This bulletin is provided for technical reference and service related updates. If you have any questions, comments or do not wish to receive these e-mails, please reply to this e-mail or call the Service Technical Support Group 800 478-1244.

BLADE SHAFT NOT ENGAGING

START RELAY RESET

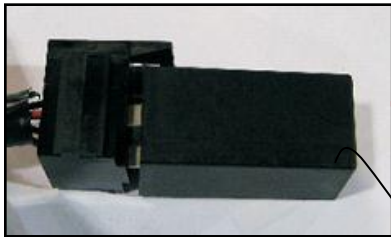
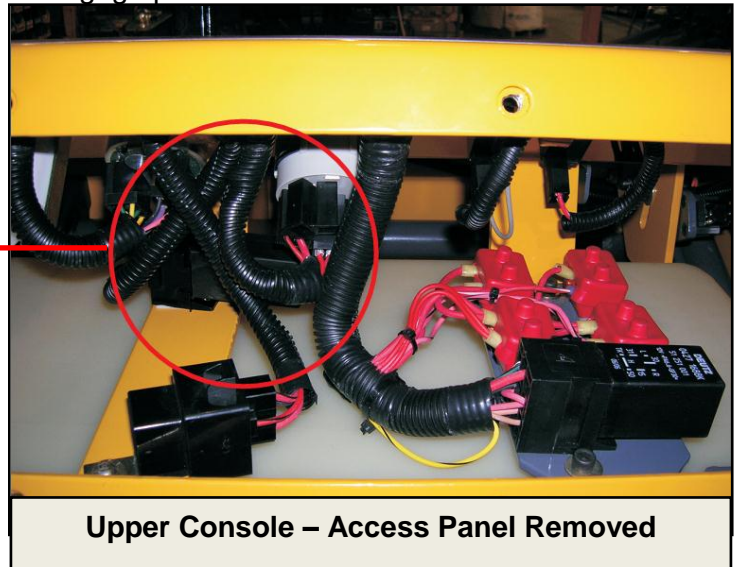
1. Pull relay completely out of connector socket.
2. Re-install the start relay in to connector socket making sure flush & firmly connected.
3. Replace console access panel and start engine.
4. Run engine to a minimum of 2000 RPM
5. Blade shaft engage / disengage switch – “engage position”.

CHECK HYDRAULIC PRESSURE

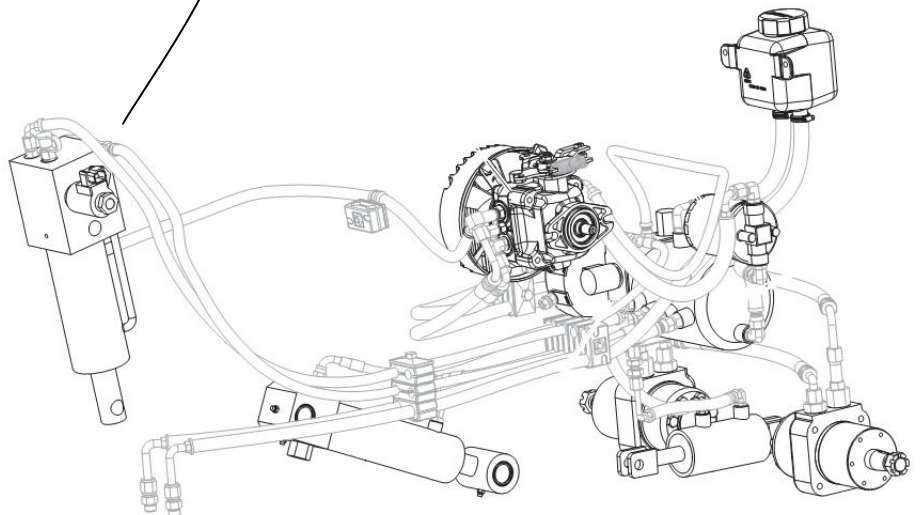
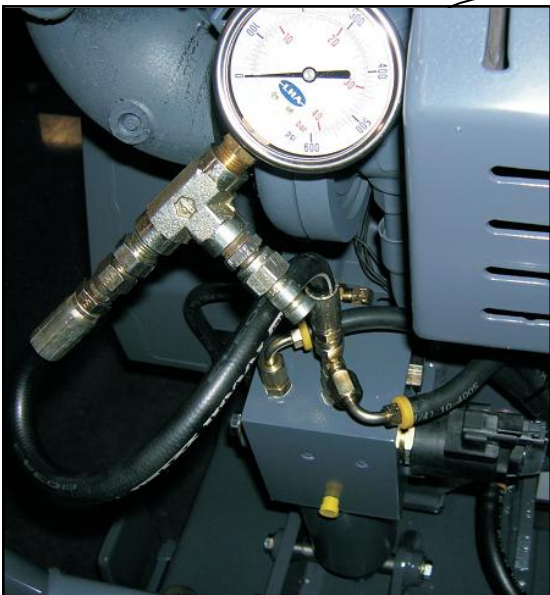
Install a pressure gauge at the lift cylinder. Normal pump pressure should measure between **(180 – 220 PSI)**. If pressure is abnormal check the integrity of the hydraulic pump.

Lift cylinder assembly

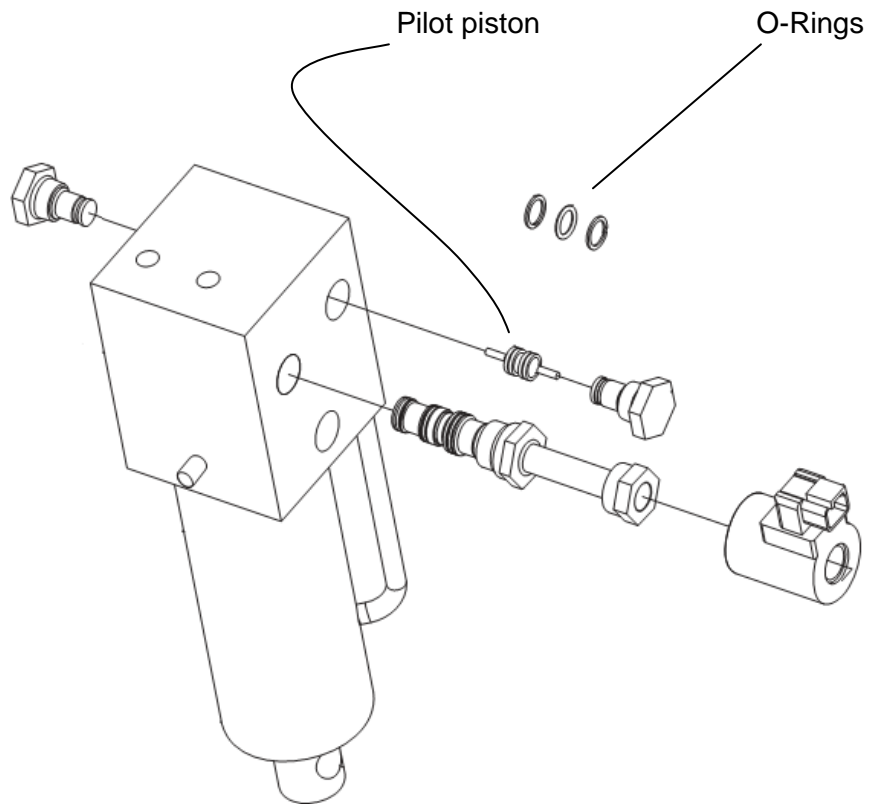
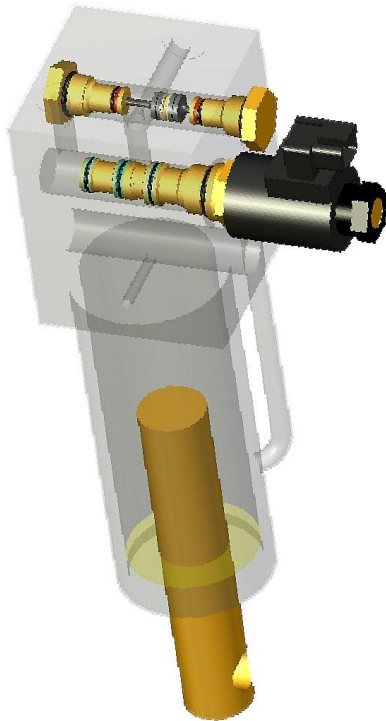
On the lift cylinder remove pilot piston and remove O-rings. Replace the pilot piston without O-rings. The pistons diameter and design are sufficient to provide proper hydraulic pressure during the cycling of the engage / disengage sequence of the saw, result: O-rings or not required to support the pilot piston.

- Remove the pilot piston O-rings if suspected engage / disengage issues are present.
- If no issues are present, remove O-rings at next hydraulic maintenance interval.

- Lift cylinder assembly.....37495
- Pilot piston.....37488
- Back up piston O-rings.....37492 removing (Qty - 2)
- O-ring.....37492 removing (Qty - 1)
